Accessibility Design Review Report

Project Title: LAHC - Seniors Housing
66-70 Pegler Ave, South Granville

Job Number: 21562

Report Version: 21562_ADR_DA_v1.0

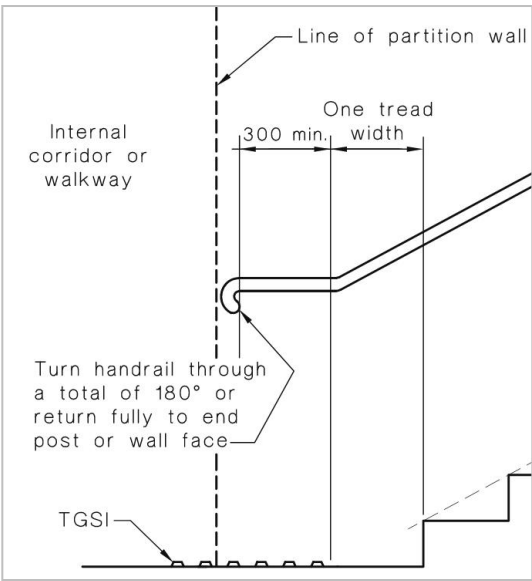
<p>external areas (<i>refer to example below or attached mark-up</i>).</p> <p>Ensure AS1428.1-2009 compliant access is achieved to storage areas & bin rooms provided for resident use.</p> <p><u>Paths of travel</u></p> <p>All pathways require a minimum unobstructed width of 1000mm. Pathways shall not include impediments such as steps or turnstiles without an accessible alternative provided.</p> <p>Circulation spaces prescribed by AS1428.1-2009 are required at changes in direction and other circumstances may require a greater width than 1000mm.</p> <p><u>Design Detail:</u></p> <p>Verification of slip resistant surface finishes on all accessways should be provided prior to OC sign off. It is recommended to refer to HB-198 for area ratings and test in accordance with AS4586-2013.</p> <p><u>Design Detail:</u></p> <p>Ensure any tracks/grooves (including for water shedding or sliding doors) and grate slots/holes are no greater than 13mm wide (depending on orientation) and are recessed to maintain flush/level pathways.</p> <p>7.5 Grates</p> <p><i>Grates shall comply with the following:</i></p> <p><i>(a) Circular openings shall be not greater than 13 mm in diameter.</i></p> <p><i>(b) Slotted openings shall be not greater than 13 mm wide and be oriented so that the long dimension is transverse to the dominant direction of travel.</i></p> <p><i>NOTE: Where slotted openings are less than 8 mm, the length of the slots may continue across the width of paths of travel.</i></p>
